**LATEST  
SURESERVO™  
FIRMWARE REVISIONS**

### Overview of Changes in Firmware Version 2.10

The latest version of *SureServo* firmware is v2.10. This firmware includes the following changes:

## P2-64

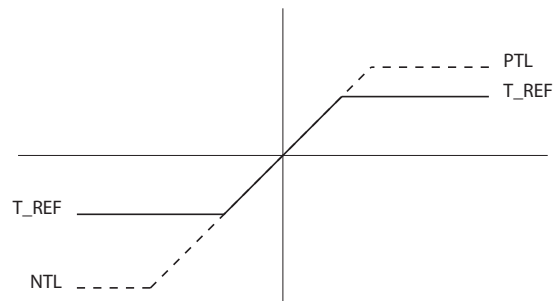
- **This parameter is new in firmware v2.10.**
- This parameter allows you to use a variable analog input Torque Limit whose range is clamped by one or more separate fixed Torque Limits. The drive applies whichever applicable limit is more restrictive; variable or fixed.
- The Torque Limit function must be enabled by P1-02 = 1x, or by a DI with setting P2-10~P2-17 = 9, 25, or 26. Different clamping characteristics are available depending upon which enabling method you use. Use only one of the methods to enable the Torque Limit function.

- 0 Disable Advanced Torque Limit function
- 1 Bi-directional Torque Limit  
(Torque Limit applies in both forward and reverse directions)
  - If  $|T\_REF| < PTL$  TL<sub>P</sub> = T\_REF
  - If  $|T\_REF| > PTL$  TL<sub>P</sub> = PTL
  - If  $|T\_REF| < |NTL|$  TL<sub>N</sub> = T\_REF
  - If  $|T\_REF| > |NTL|$  TL<sub>N</sub> = NTL
